Subject: BFJ response to comments on the proposed zoning for Municipal Place and North Riverside

Date: December 31, 2019

## Municipal Place Gateway and North Riverside Neighborhood Zoning Study and Proposed Zoning Changes

**Figure 1: Build-out concept 1 – Multi-family building**

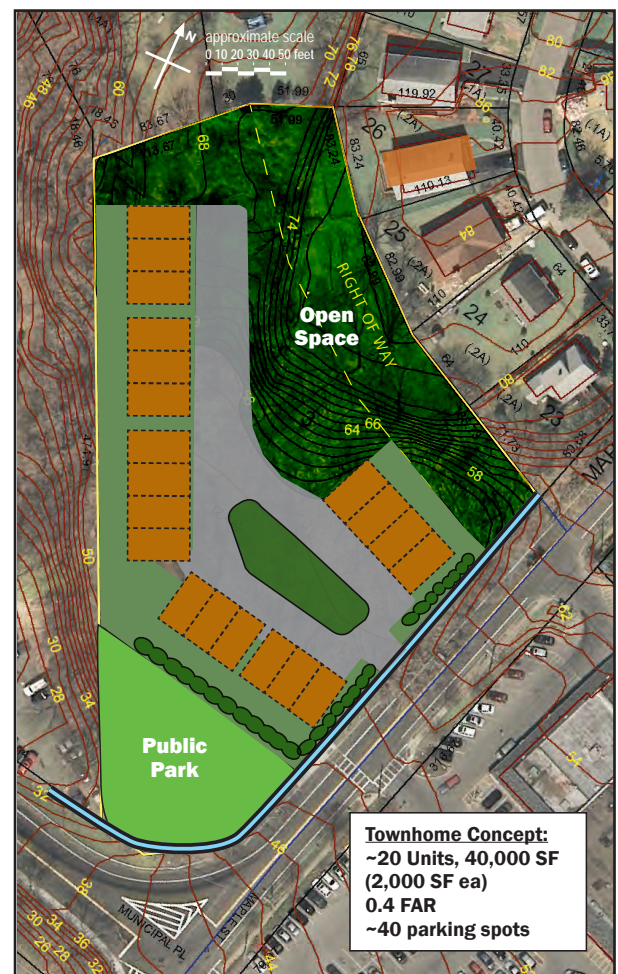
There were questions regarding the analysis of the number of units that could be built on the Katz property. The number of units that could be accommodated is largely dependent on whether parking is provided at grade or structured. It is reasonable to assume that an at-grade parking scenario is far more likely as the cost to build structured parking is not justified in today's real estate market. Preliminary layouts of housing by BFJ Planning indicate that around 40-45 units could be provided with a multi-family building. This layout was provided in the study and is shown below in Figure 1. The layout assumes a building of approximately 42,000 square feet and an average unit sizes of 1,000 square feet (including residential areas and common areas), which is a reasonable assumption. Naturally, if the apartment mix were skewed towards smaller apartments, there could be a slightly larger number of units.

Given the concern about the number of units, we would recommend reducing the FAR from 0.8 to 0.5, which is the FAR in the underlying C-2 district. Both a multi-family and a townhouse development can be reasonably built out within the existing C-2 FAR of 0.5. The layout shown has an FAR of 0.42.

For townhomes, the number of units would be less (between 20-25 units) depending on the size of unit and also assumes surface parking. A rough sketch of this scenario is shown in Figure 2. The 20 units shown assumes unit sizes of 2,000 square feet. Parking will be a key limit on the number of townhomes. The layout of the site is also limited due to the steep topography.

Figure 3: Proposed 50 foot buffer at Katz Property

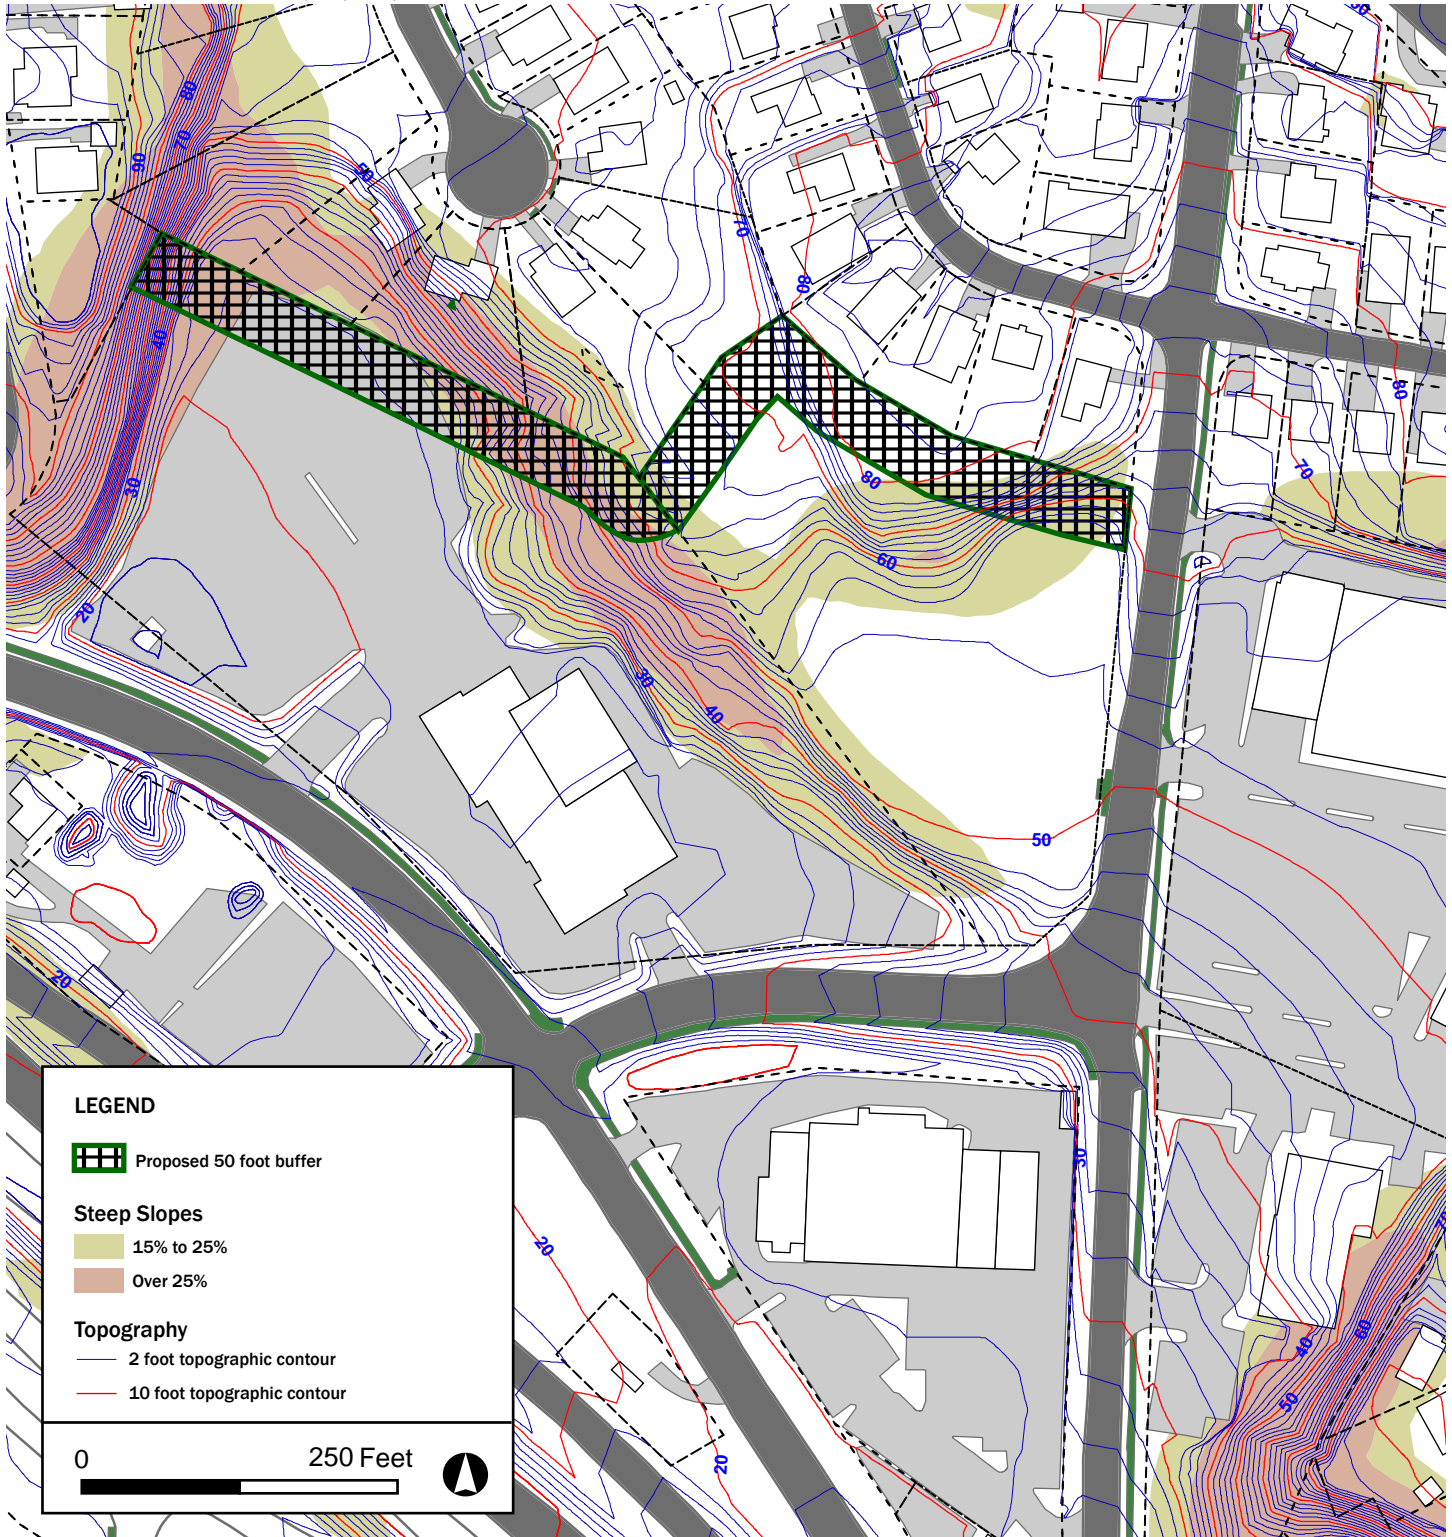
The public raised the issue of potential impacts to views from upland properties and requested the Board consider extending the 50 foot buffer. The existing zoning text provides for a 50 foot vegetated buffer for the properties along Wells Avenue. It was asked that this buffer also include the properties along Beekman Avenue. This seems to be reasonable. The modified buffer area is shown in Figure 3. These buffer areas are not considered to be attractive locations for development due to the steep slopes. This buffer is located on both the Katz property and the Croton Auto Park property.

It was asked if this buffer could also include the properties along Beekman Avenue. This seems to be reasonable and we have illustrated it. The illustration shows this buffer on both the Katz property and the Croton Auto Park property.

**Figure 4: Steep Slopes and Viewshed Analysis**

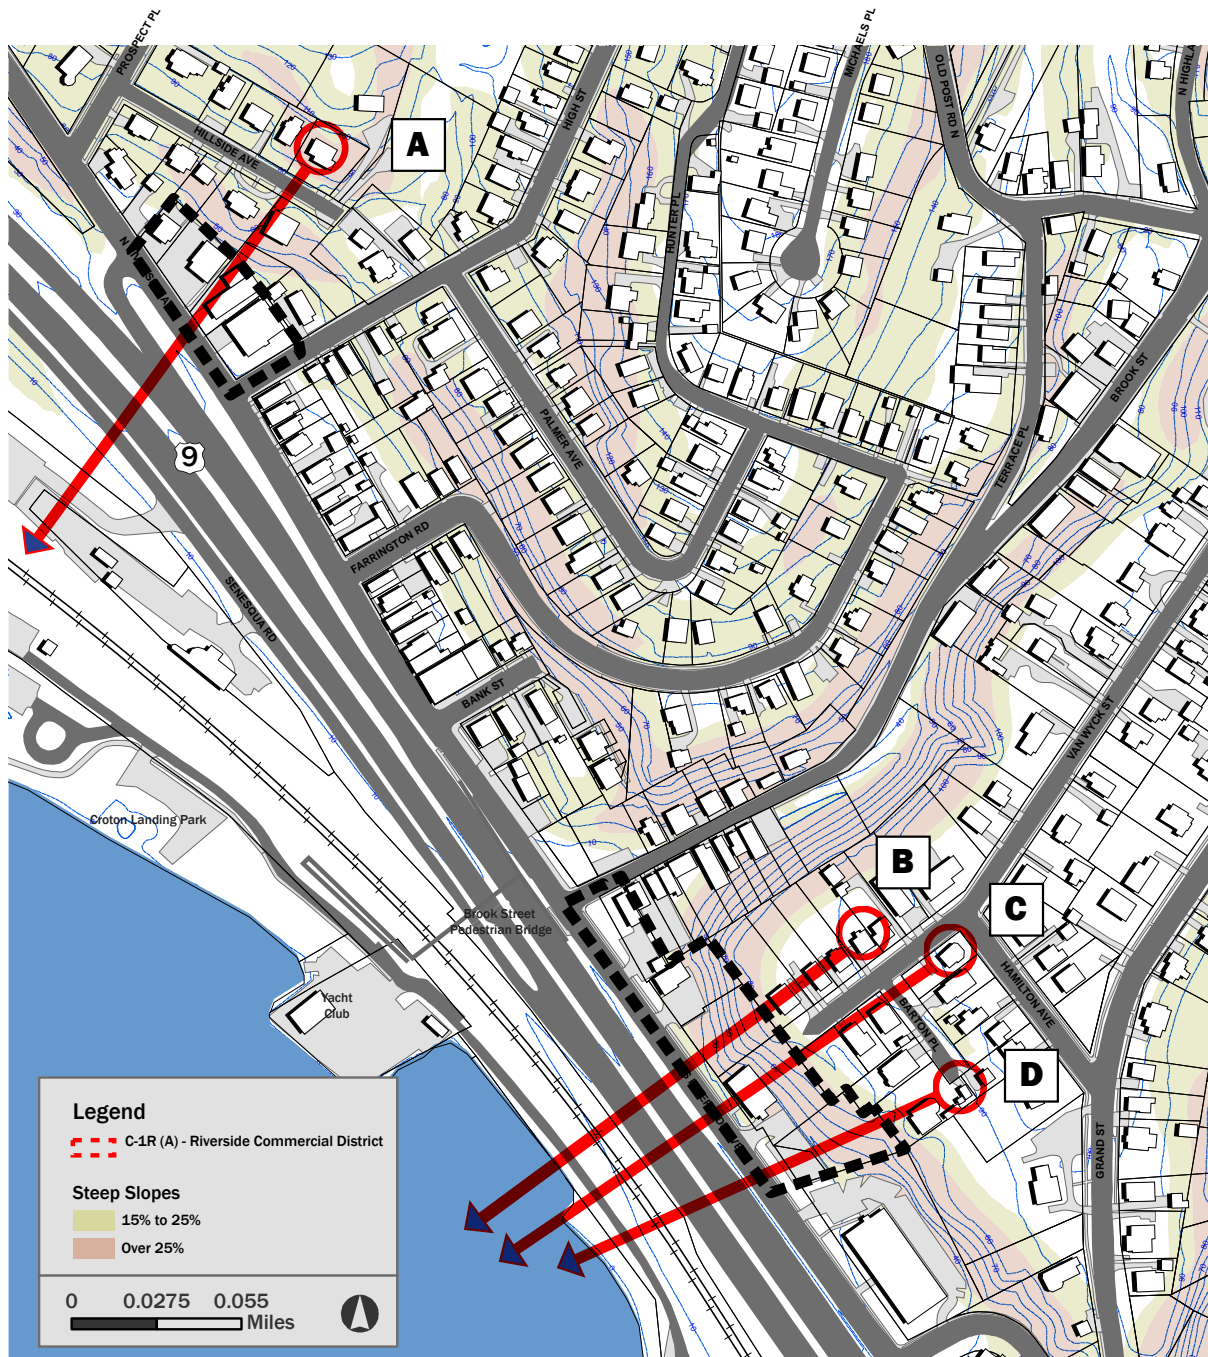
The Board of Trustees asked that additional diagrams be provided to show views from additional upland areas (see Figure 4 for the location of these upland areas). The sections provided in Figure 5 show that the buildable areas along Route 9A are generally tucked under a steep slope with a 40-50 foot elevation change. This slope is also vegetated. The dashed boxes at each of the sites shows building with a height of 35 feet. As shown, building to the existing allowed height of 35 feet would not impact existing views from upland properties. It is important to note that the maximum building height of 35 feet will not change from what is allowed in the existing zoning district.

Additional diagrams are provided to show views from upland areas. Due to the existing slopes, new development would not impact views. It is important to note that the maximum building height of 35 feet will not change under the proposed zoning.

Figure 6: Elevations and South Riverside Drive

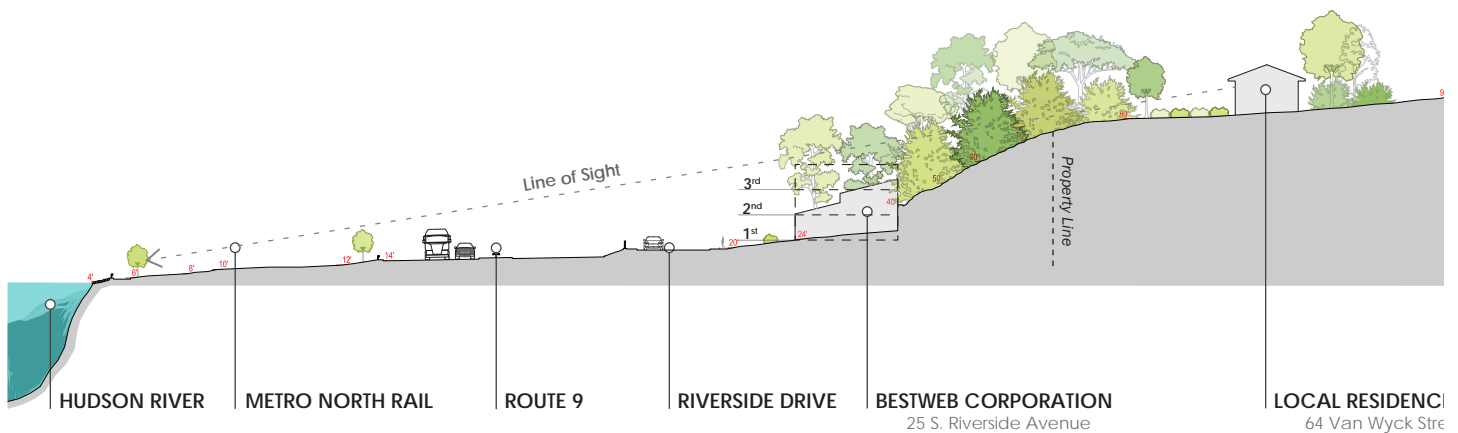
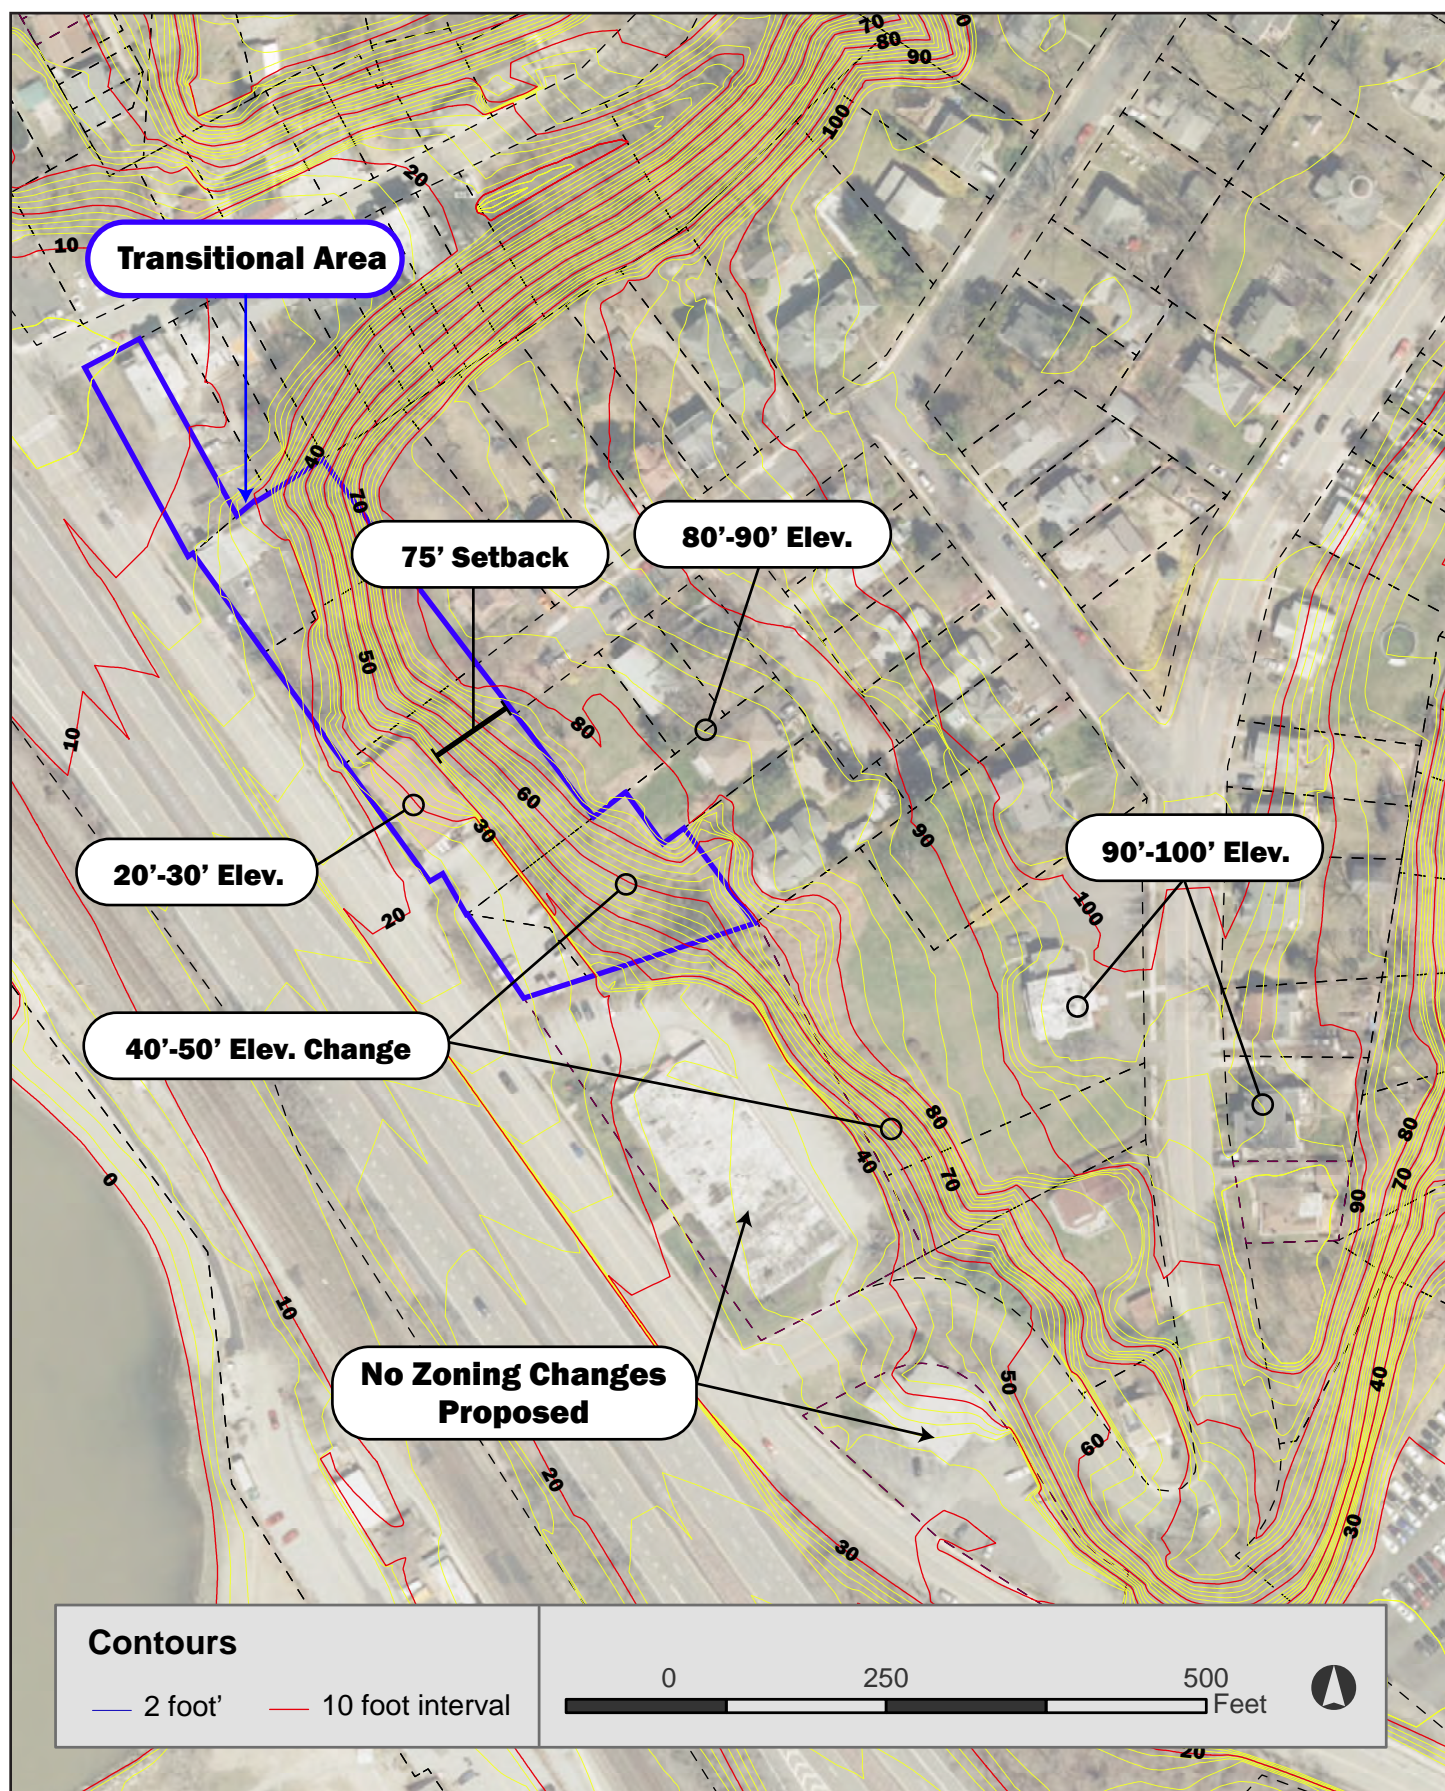
The Board of Trustees heard some concerns from upland properties that rear yard setbacks may be needed to buffer upland areas from potential C-1RB development. As seen in Figure 6, there is a steep vegetated slope between the upland areas and the flat areas along South Riverside Avenue. The steep slope is located within the rear portion of the properties along South Riverside Avenue. At the former hardware store (25 Riverside Avenue), the sloped area from the building to the property line is 75 feet in depth.

The most effective way to limit encroachment onto this slope is the existing steep slope ordinance. If a development sought to build into the slope, unless the encroachment was minimal, the applicant would have to obtain a steep slope permit from the Planning Board. The steep slope ordinance has 16 review standards provided in §195-3.

A second layer of protection is a rear yard setback. The current C-1 zones provide for either 0 or 10 feet if a setback is provided. We recommend establishing a 10 foot setback for the rear yard in the C-1RB zone. We would also give the Planning Board the right to double this setback in areas where a steep slope permit is needed and provided the lot has a sufficient lot depth. Thus the Planning Board could increase the rear yard setback to 20 feet if it determines that application of the steep slope permit process does not provide a sufficient buffer, and the configuration of the lot allows for both the 15 foot setback from the sidewalk and the larger rear yard setback.

It should be noted that the baseline 10 foot rear yard setback is all that can be required for the northern section of the proposed zone due to the smaller lot depths.
